Technical Memorandum

Re: Response to Comments: Arlington Garden Apartments-Binding Site Plan PLN # 1263 and Conditional Use Permit PLN # 1264 (The Apartment Project)

Appendix A – Updated Existing Conditions Exhibit

DATE: 4/11/2025
 JOB: 2783.0001
 BY: DS
 SCALE: 1" = 370'
 FIGURE NO. 1 of 5

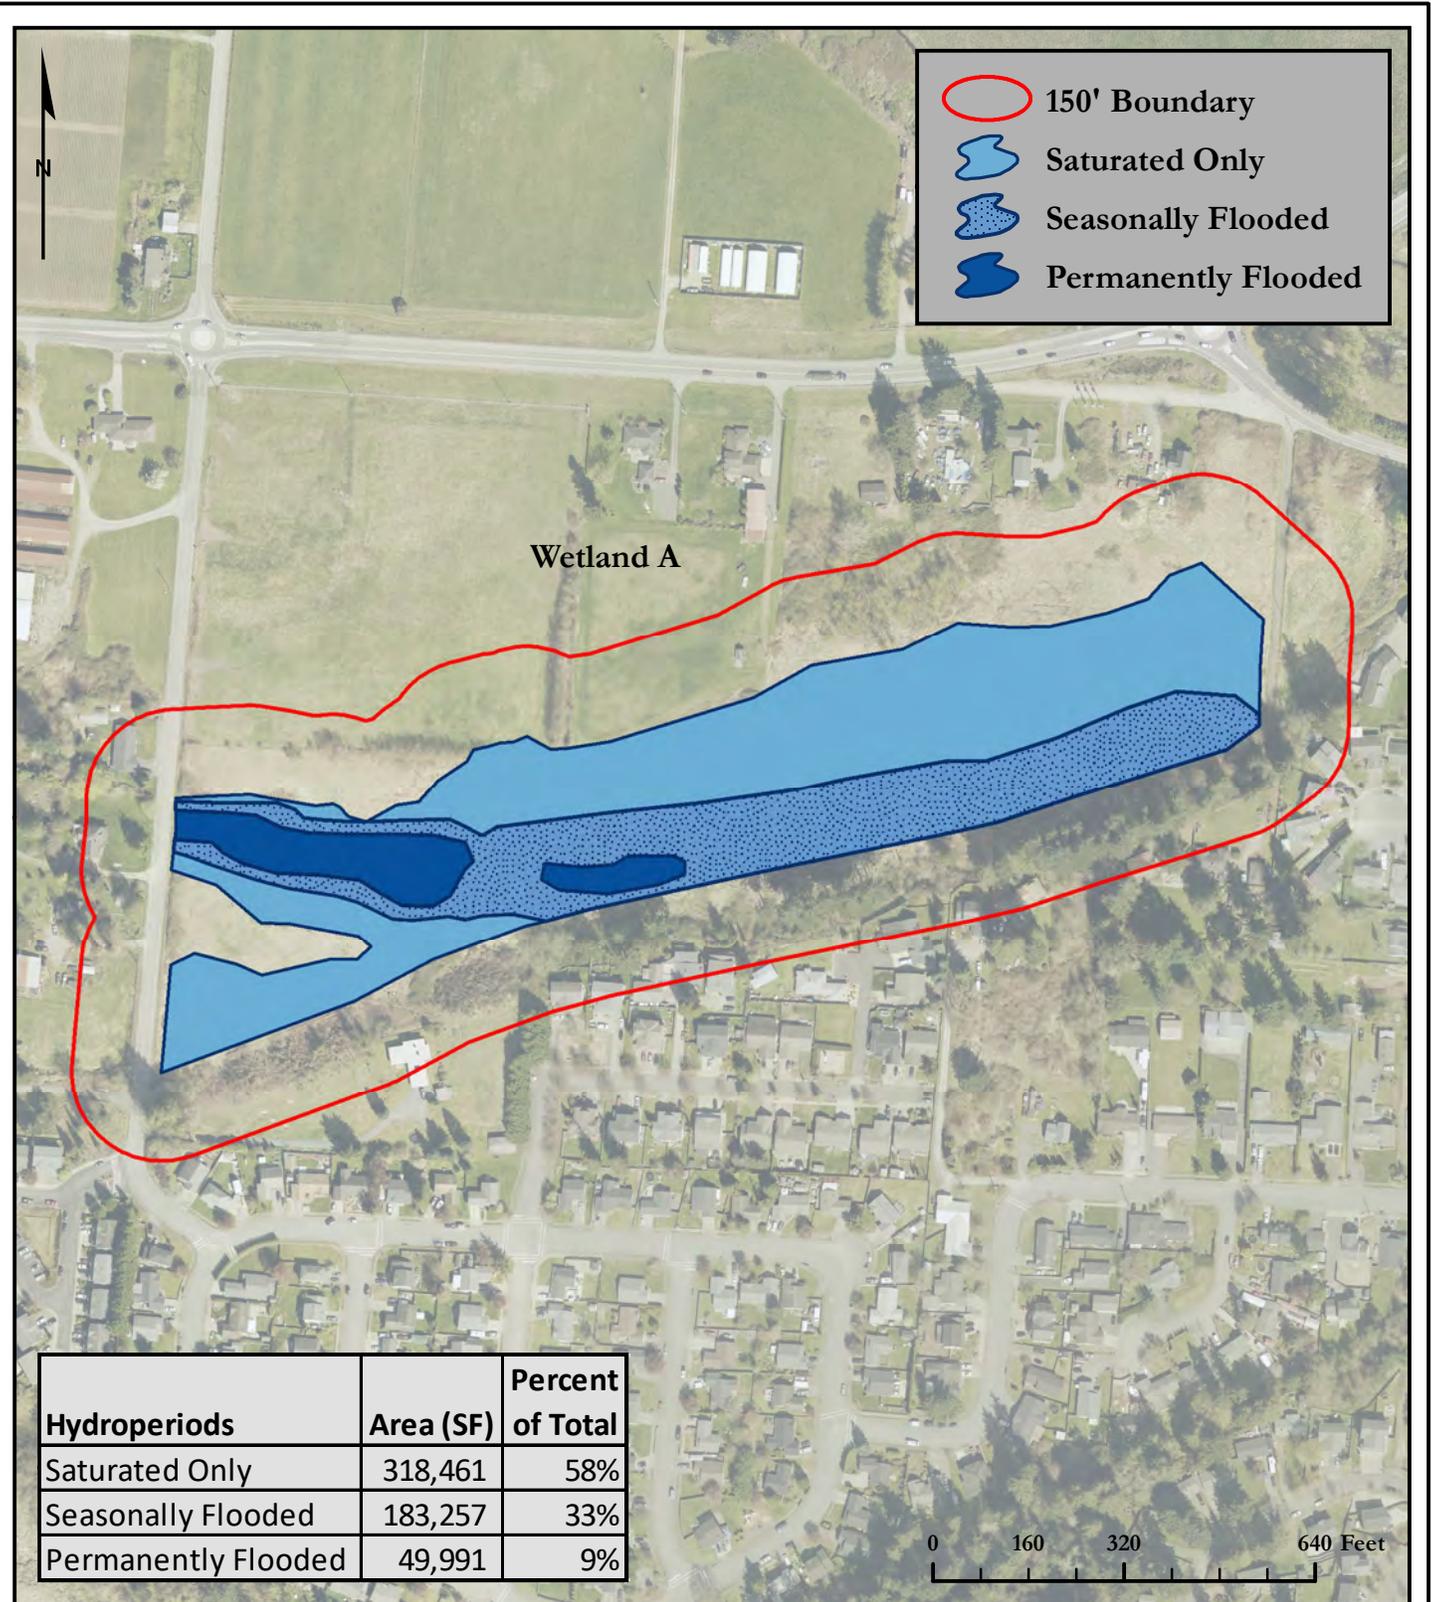
11. *In my professional opinion, Question H1.1 on the Wetland Rating Form prepared and submitted by Soundview Consultants, LLC is also not accurate. The subject wetland includes emergent and scrub-shrub*

Cowardin vegetation classes. The rating form figure (Figure No. 1 of 5) that Soundview Consultants, LLC attached to their report differs from how they scored this question on the Wetland Rating Form. I don't think that the wetland rating unit contains a forested class across 15% of the wetland (as shown in the Wetland Rating Form Figures prepared by Soundview Consultants, LLC), but there is definitely a scrub-shrub class that exceeds the thresholds listed in questions H1.1. The number of points assigned on the Wetland Rating Form prepared and submitted by Soundview Consultants, LLC does not match their own figure which is Figure No. 1 of 5. That would increase the number points on that question from 0 to 1 (or from 0 to 2 points if they include a Forested vegetative class as depicted on their Figure No. 1 of 5). Either way, the point total for Question H1.1 is not accurate as 0 points as shown on the Wetland Rating Form prepared and submitted by Soundview Consultants, LLC.

SVC agrees that Wetland A is comprised of two Cowardian classes, emergent and scrub shrub. It is noted that a small forest patch was observed near the southeast portion of the wetland. However, upon desktop review and additional site visits to the subject property and adjacent accessible areas, it has been determined that the forested area is not located within the boundary of Wetland A, as the forested area is actually located on the hillslope to the south of the wetland and is therefore not accounted for as a Cowardian class. The Wetland A rating form and associated ratings figures map have been updated to reflect that Wetland A contains only scrub shrub and emergent Cowardian vegetation classes within Wetland A. One point has been allocated to Question H1.1. Updated Wetland Rating Maps are provided in Appendix C of this Technical Memorandum.
